SERVICE BULLETIN

COLLINS RADIO COMPANY

EQUIPMENT TYPE: KWM-2, KWM-2A TRANSCEIVER

SUBJECT: ADD VOX RELAY TIME CONSTANT CONTROL.

Figure 1. KWM-2/2A VOX Circuit Schematic Changes

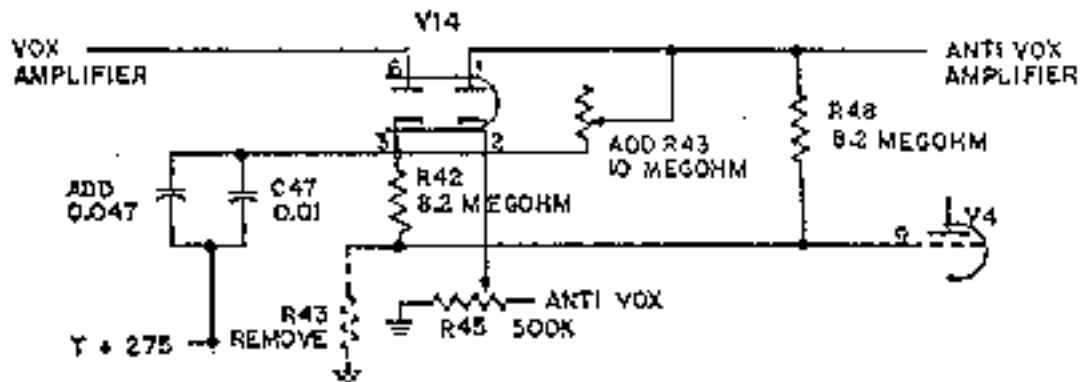
See figure 1 for circuit changes.

1. Remove the feet from cabinet.
2. Lift lid and remove the two unpainted screws from the top rim of the front panel.
3. Slide unit out of cabinet.
4. Remove and discard the 10-megohm resistor R43 located between V4, pin 9 and ground.

Figure 2. Parts Location - Under Chassis

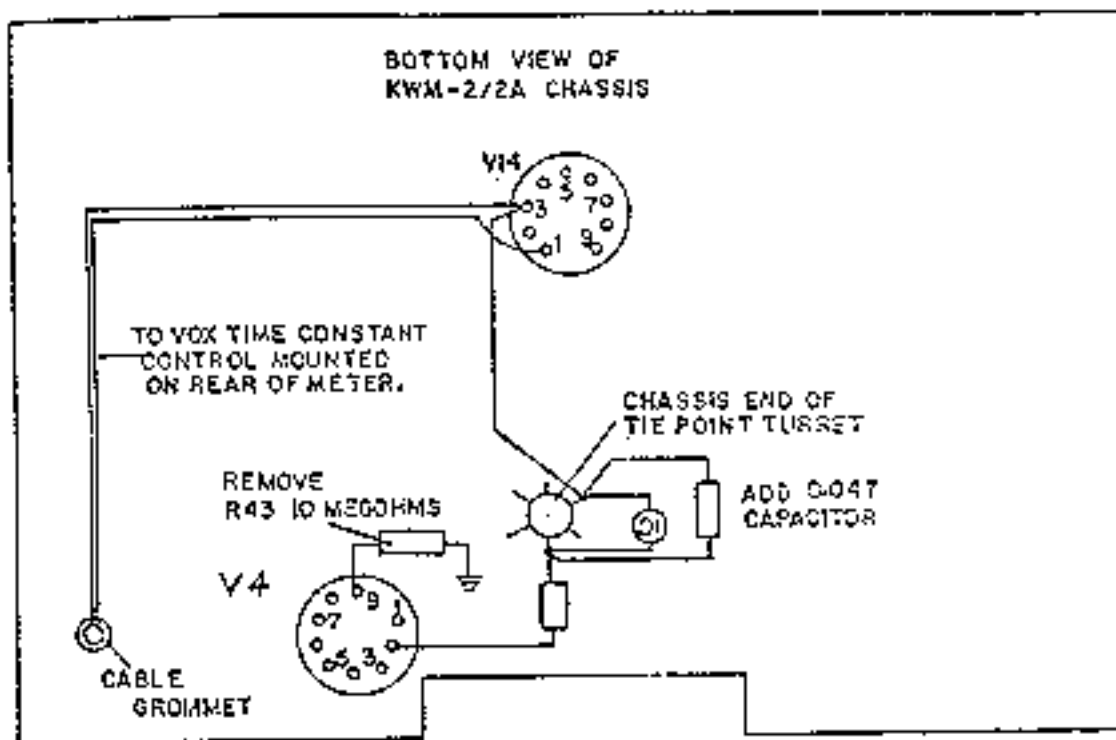
5. Add 0.047-uf capacitor (931-0295-00) in parallel with 0.01-uf disc capacitor located between pins 1 and 3 of E50. E50 is a mounting turret post located between XV4 and XV14 tube sockets. Sleeve leads of new capacitors with insulation (152-1613-00). See figure 2.

Figure 3. Installation of VOX Time Constant Control and Brackets

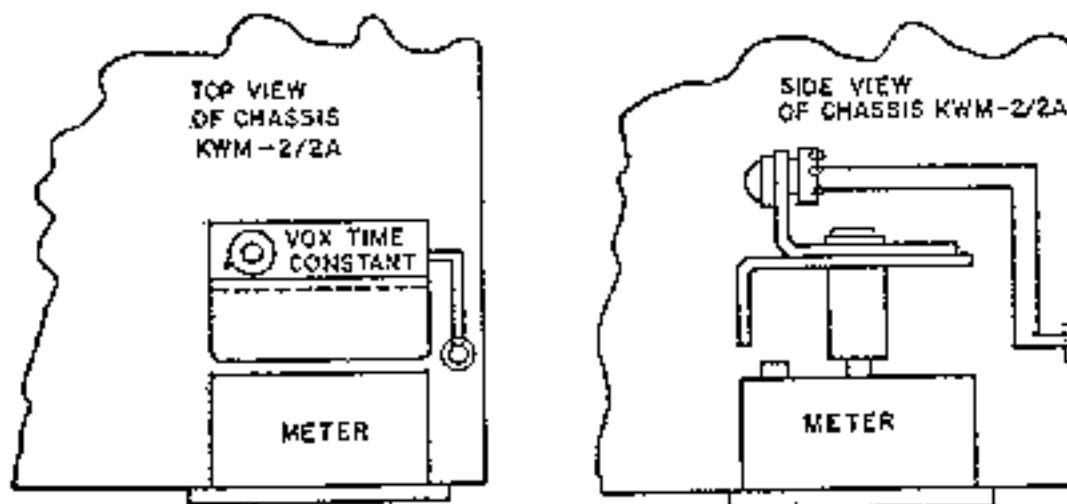
7. With transceiver in upright position, remove the two nuts holding the shield to the back of the meter.
8. Mount VOX TIME CONSTANT control bracket (546-7971-00) on the meter shield using hardware removed in step 7. See figure 3.

9. Solder either one of the 18-inch wires to the center terminal of the control.
10. Solder the other wire to the counterclockwise terminal (as viewed from the shaft end) of the control. Refer to figure 3.
11. Mount VOX TIME CONSTANT control (376-7206-00) in the new bracket, using hardware and knob included in kit.
12. Reassemble unit.

KWM-2 After Modification, Schematic Change

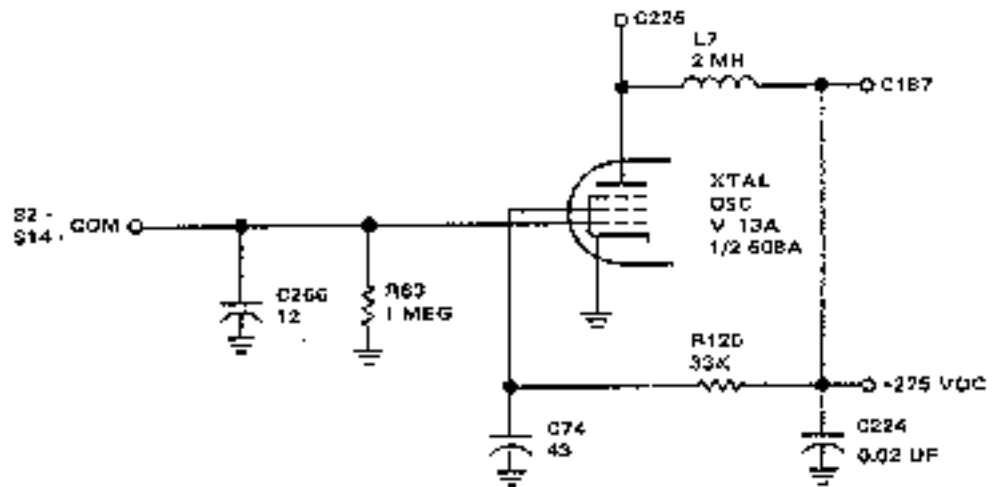
- c. Remove and discard 27-pF capacitor C266, if present, from XV13A pin 2 to the center shield of V13 (ground), and install at this location a 12.0-pF capacitor (912-2757-000), KWM-2 only.
- d. Remove and discard 47-kΩ resistor R125 from XV13A pin 2 to vector terminal board E100, and replace with 33-kΩ resistor (745-1415-000).
- e. Remove and discard 47-pF capacitor C74 from XV13A pin 3 to ground, and replace with 43.0-pF capacitor (912-2789-000).
- f. Inspect unit for damage incurred during modification, dress wires and cables, and remove debris.
- g. Reassemble unit by reversing step a.
- h. Check transceiver for proper operation.
- i. Mark information chart (280-3778-010) 5B 3R. Apply chart to convenient location on unit if one is not present.

Figure 1. Schematic Diagram, After Modification

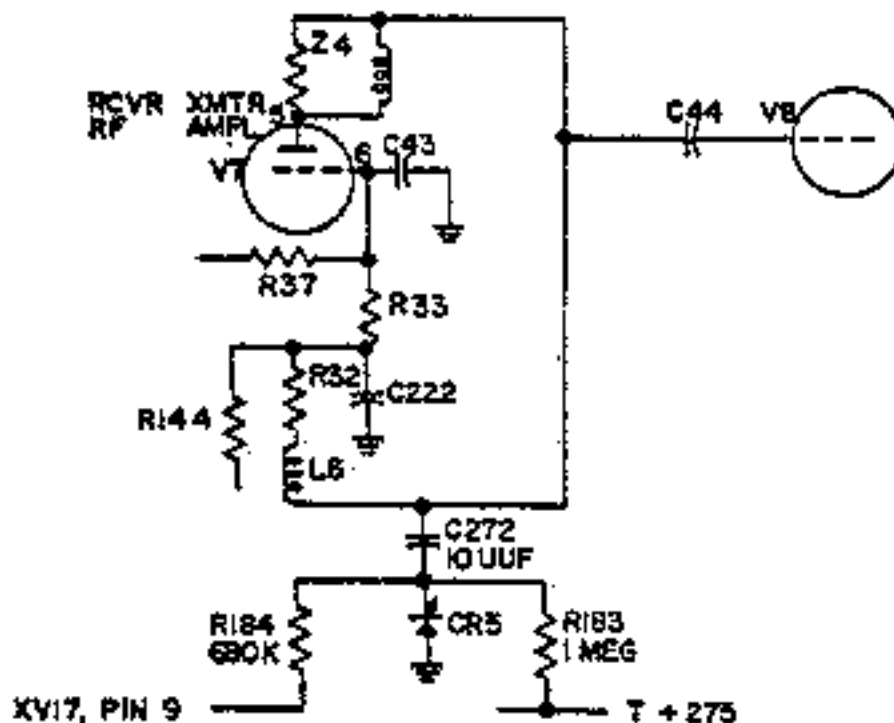
1. Connect new 10-uuf capacitor C272 (912-2753-00) from terminal "I" at the chassis end of parts mounting turret E80 to point "D" on the same mounting turret. Do not solder "D" connection.

2. Connect new 680K-ohm resistor R184 (745-0851-00) from tube socket XV17, pin 9 to tie-point "D" on parts mounting turret E80. Do not solder "D" connection.

3. Observe polarity of silicon capacitor CR5 (922-6002-00). Connect anode (end marked with manufacturer's trade mark) to the ground shield of tube socket XV7. Connect cathode (color coded end) to tie point "D" on parts mounting turret E80. Do not solder "D" connection.

4. Connect new 1 meg-ohm resistor R183 (745-0857-00) from tie point "B" on parts mounting turret E70 to tie point "D" on parts mounting turret E80.
5. Solder connections to tie point "D".

Figure 1. Location of Components Affected by this Modification.

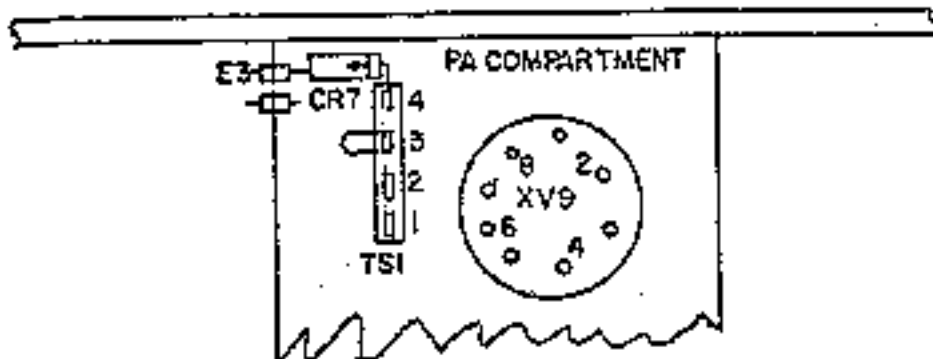
1. Remove cover of unit.
2. Connect a voltmeter from terminal 3 of tube socket XV9 to chassis ground. Set meter on 300-volt scale.
3. With power applied, turn EMISSION switch knob to LOCK KEY. Meter should read approximately 280 volts.
4. Turn EMISSION switch knob to USB so that unit is in receive function. Immediately upon switching, turn meter to 30-volt scale. If voltage is indicated and dies off slowly, there is screen grid emission on one or both 6146 tubes.
5. If screen grid emission is present, remove bus wire that is connected from terminal E3 (feedthrough terminal located near rear apron in PA grid box) to terminal 4 of terminal strip T51. Install in its place a 1N1490 diode (353-1659-00) with anode connected to E3. Refer to figures 1 and 2.

KWM-2/2A Chassis, Component Locations, Bottom View
Figure 1

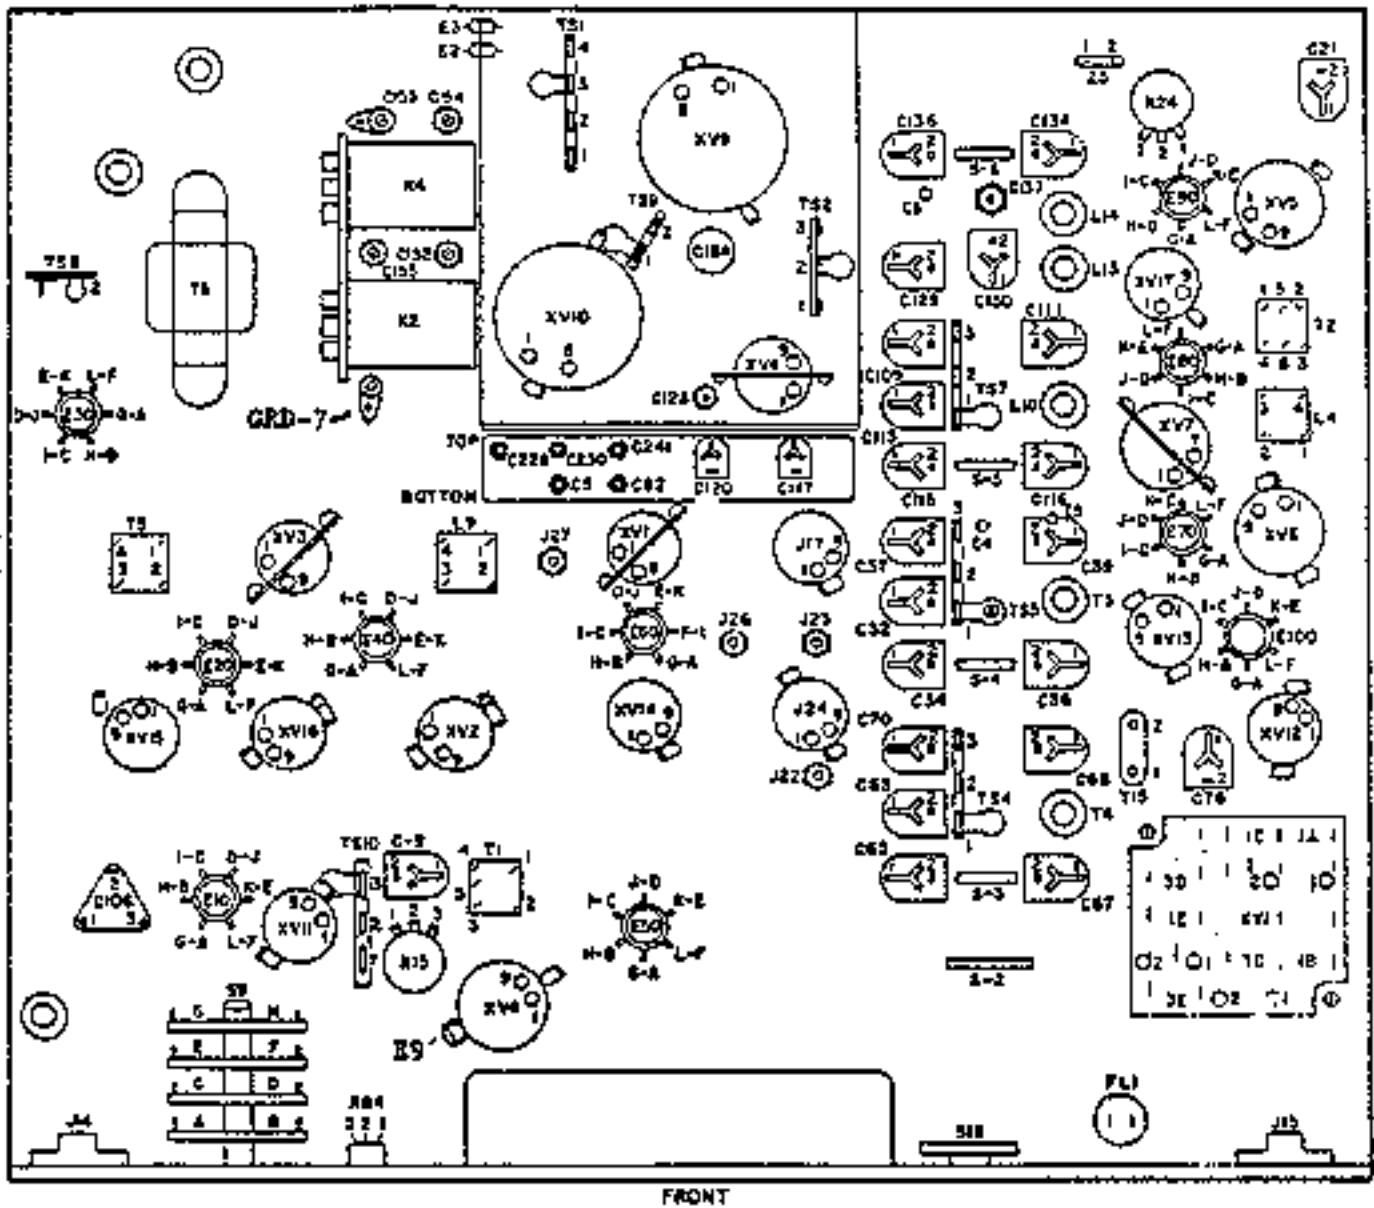
1. Place KWM-2 upside down, and remove four feet and screw located between two rear feet.
2. Turn unit over and release two lid fasteners.
3. Remove two unpainted flathead screws located under front edge of cabinet lid.
4. Remove KWM-2/2A from cabinet.
5. Position unit upside down with front side to the right. Refer to figure 1 for component locations.

NOTE: Newer KWM-2/2A units have this modification installed. At this point, following step 5, you may determine whether your unit has all (or part of) the modification installed. Referencing figure 1 with the unit, look for plastic encased relays K2 and K4 and for terminal E9 with a 12-k Ω resistor to pin 8 of tube socket V4. The presence of these components indicates inclusion of the basic modification.

20. Install ground lug (304-2800-000) on capacitor C153 (figure 1) with shake washer (373-7050-000) between lug and chassis.
 21. Disconnect white wire and white-red-orange wire at Terminal strip TS3-2 and reconnect white wire to ground lug installed in step 20. Reconnect white-red-orange wire to terminal B on relay mounting bracket (figure 3). If either wire is found to be too short, replace entire wire with equivalent type and proper length. Discard terminal strip TS3.

KVM-2/2A Relay Mounting Plate Drilling Instructions
Figure 2

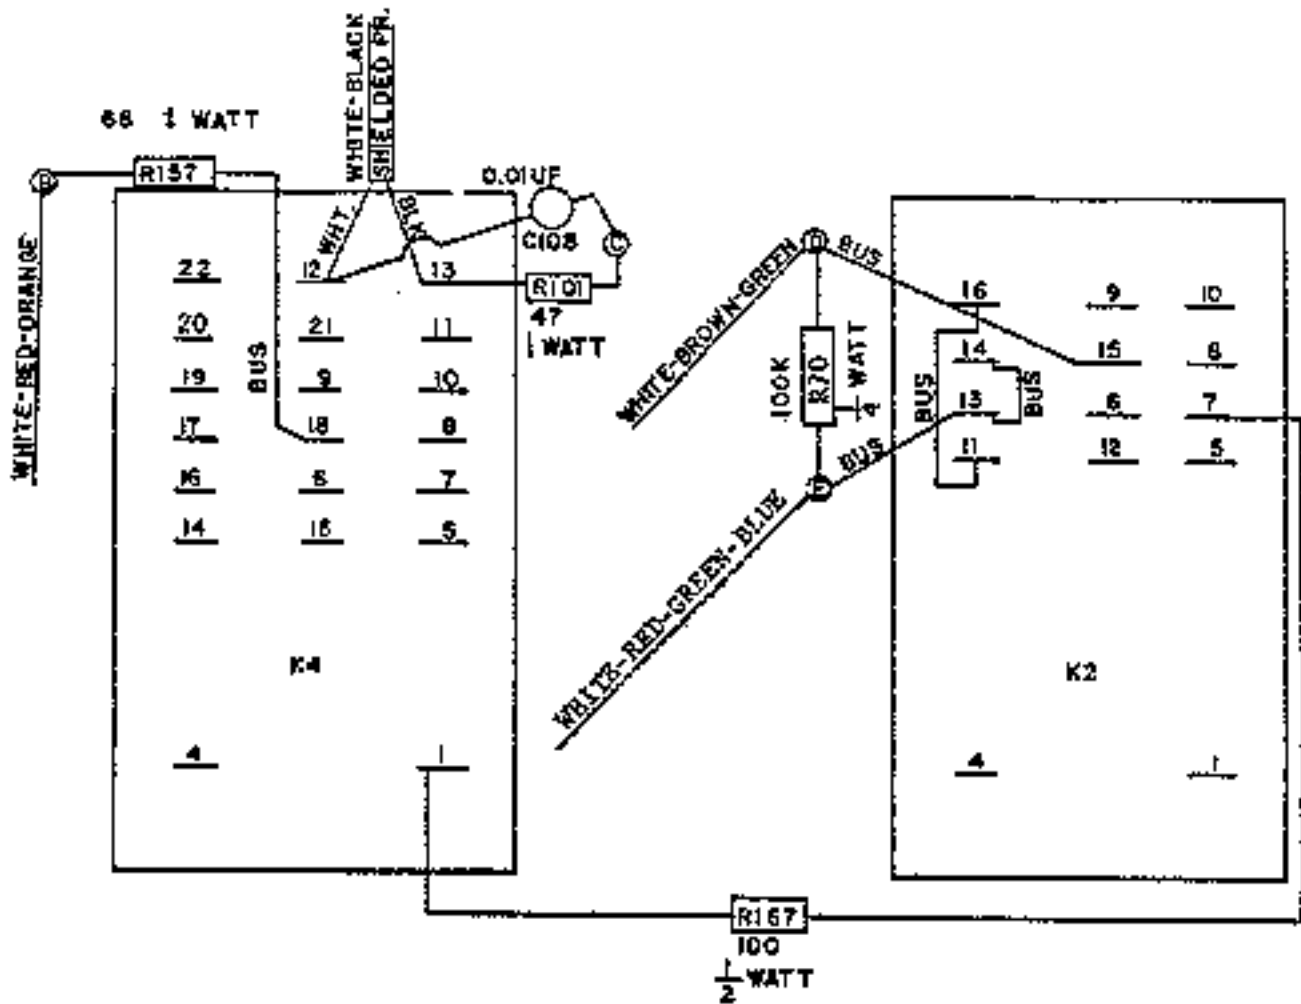
NOTE: A number of relay mounting brackets already have the hole A drilled to proper size and location. Check bracket (768-5928-001) with figure 2, and if hole A exists, disregard step 13.

13. Drill hole in relay mounting bracket (768-5928-001) according to the instructions on figure 2.
14. Position relay bracket in chassis with hole B centered on the sheet metal screw located approximately 1 1/4 inches from PA cage, with bracket parallel to the PA. Holding in this position, center punch through bracket holes A and C.

CENTER PUNCH AT CENTER LINE A. DRILL 0.125-INCH DIA.

Part A, Schematic Change

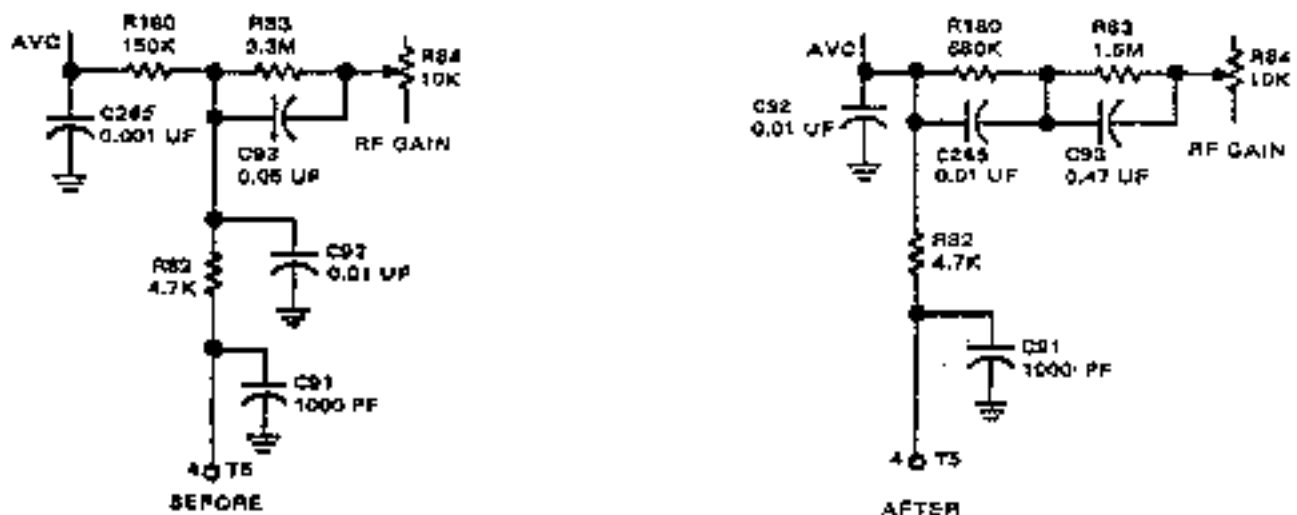
- (a) Place transceiver upside down on workbench with knobs to the right. Remove and save the screws used to attach the two nylon cable buttons to the strengthening rail. Remove and save the screw attaching the rear of the strengthening rail to the chassis. Remove and save the screw attaching the front of the strengthening rail to the chassis, taking care not to lose the nut, lockwasher, and flat washer underneath the rail. Remove the rail, saving any protective material located between the cable and the rail.
- (b) Remove all components attached to E30-C, as follows:

- 1) 4700-ohm 1/4-W resistor, R82, connected from T5 terminal 4 to E30-C.
- 2) 0.01 μ F disc ceramic capacitor, C92, connected from E30-I to E30-C.
- 3) 3.3-m Ω 1/4-W resistor, R83, connected from E30-C to E30-J.
- 4) 0.05- μ F capacitor, C93, connected from E30-C to E30-J.

- (c) Remove 0.001- μ F disc ceramic capacitor, C256, connected from T53-1 to ground ring on power connector.
- (d) Connect R83, 1.5-M Ω 1/2-W resistor (745-1485-00), from E30-C to E30-J.
- (e) Connect C93, 0.47- μ F capacitor (913-3804-00) from E30-C to E30-J.

- (f) Connect R82, 4700-ohm 1/2-W resistor (745-1380-00), from T5 terminal 4 to TS8-1. Use sleeving on leads and route this resistor around E30.
- (g) Connect R180, 680-k Ω 1/2-W resistor (745-1471-00), from TS8-1 to E30-C.
- (h) Connect C265, 0.01- μ F disc ceramic capacitor (913-3013-00), from TS8-1 to E30-C.
- (i) Connect C90, 0.01- μ F disc ceramic capacitor (913-3013-00), from TS8-1 to ground ring on power connector.
- (j) If no additional modifications are to be implemented, replace all hardware by reversing step (a).
- (k) Mark SB 8A on information chart (280-3778-010) and apply chart to convenient location on unit, or mark existing chart if one is present.

Part B Schematic Change

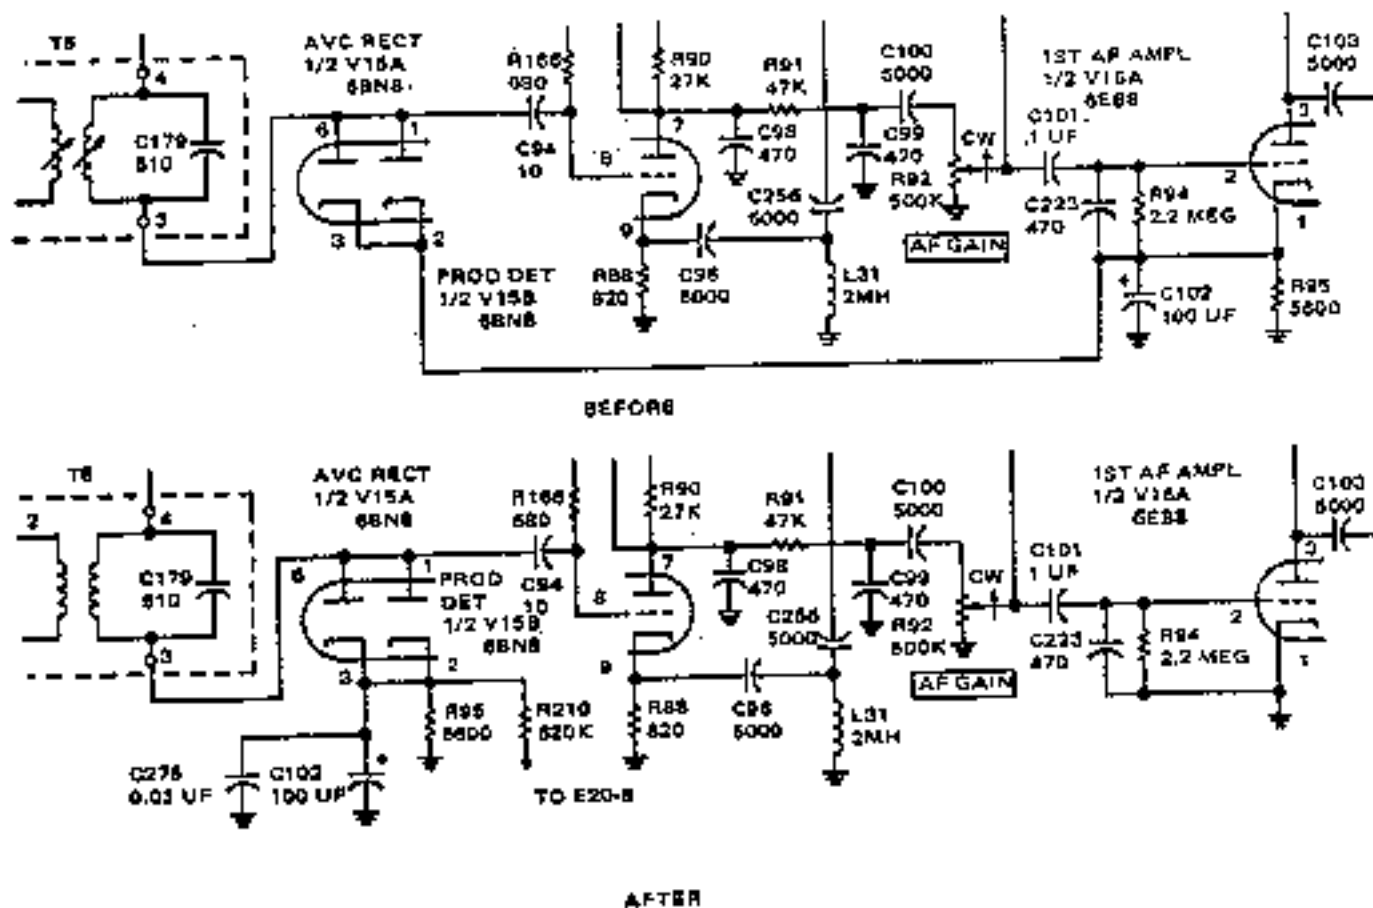
- Disconnect bus wire at tube socket XV15-2. Remove sleeving and route wire to center shield on XV16. Shorten wire as necessary, connect and solder.
- Add 620 k Ω resistor R210 (745-1469-000) from E20-B to XV15-2.
- Add 0.01 μ F capacitor C275 (913-3013-000) from XV15-3 to nearest ground.
- Mark information chart (280-3778-010) SB 8B. Apply chart to convenient location on unit if one is not present.
